**SUBJECT:** NuScale Power, LLC Supplemental Response to NRC Request for Additional Information No. 83 (eRAI No. 8899) on the NuScale Design Certification Application

## **Response to Request for Additional Information Docket No. 52-048**

**eRAI No.:** 8899

**NRC Question No.:** 19.01-2

Figure 19.1-16: Representative Seismic-Initiating Event Tree

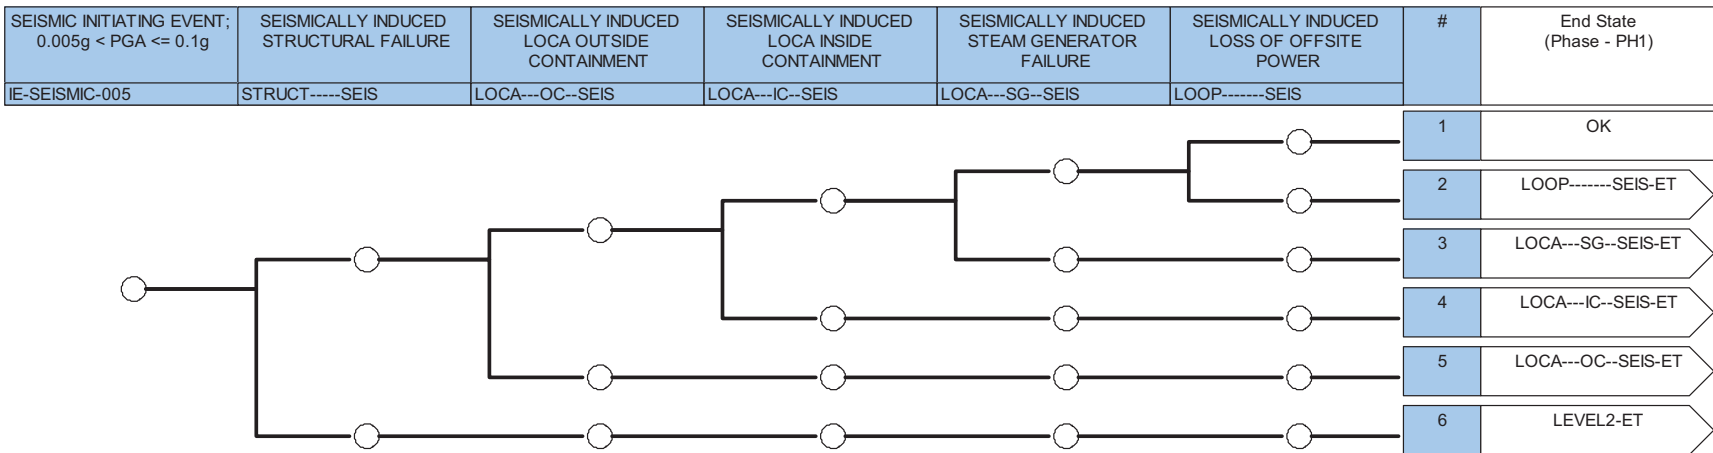
In FSAR Tier 2, Section 19.1.5, the staff identified the use of the terms “PRA-critical” and “Non-critical.” The staff requests that the applicant provide a definition of the terms “PRA-critical” and “non-critical” that are consistent with their usage as listed below and applicability to the PRA-based SMA.

Additionally in Section 19.1.5.1.1.3, the 2nd paragraph describes the methodologies used to determine the seismic capacity and demand for the SMA. The staff requests that the applicant clarify if the 1st sentence in that paragraph is referring to PRA-critical structures and components. The applicant should also clarify if non-critical components are modeled in the SMA and whether there are any non-critical structures.

~~The seismic hazard for the NuScale design has been partitioned into 14 seismic initiating event trees defining the SMA. The underlying logic for each tree is identical. However, each tree represents a different ground motion acceleration.~~ The seismic hazard for the NuScale design SMA is partitioned into fourteen seismic event trees. The underlying logic for each event tree is identical; however, each event tree represents a different ground motion acceleration (each seismic event tree represents a portion of the ground motion range from 0.005g to 4.0g). In the SMA, the use of multiple ground motions provides insights into the relative contributions of both seismic and random failures at different ground motions. Figure 19.1-16 is a representative seismic event tree, corresponding to a range of peak ground accelerations from

0.005g to 0.1g. In each event tree, the initiating event frequency is set to unity in the SMA to produce the conditional probability of core damage given a seismic event.

Each event tree is assigned a ground motion acceleration increasing monotonically from 0.005g to 4.0g. The seismic initiator event tree provided as Figure 19.1-16 corresponds to a range of peak ground accelerations from 0.005g to 0.1g. The thirteen remaining event trees represent ground motion ranges spaced accordingly up to 4.0g (0.1g to 0.2g, 0.2g to 0.4g, ..., 2.0 to 2.5g, ..., 3.0g to 4.0g). Component failure probabilities are then evaluated at the mid-point of each range (0.0525g for a range of 0.005g to 0.1g, for instance). This methodology supports site-specific estimates of seismic hazard occurrence frequency. Each ground motion initiator is a SAPHIRE initiating event with a frequency set to unity. This allows for an evaluation of conditional core damage or large release probability at each ground motion.
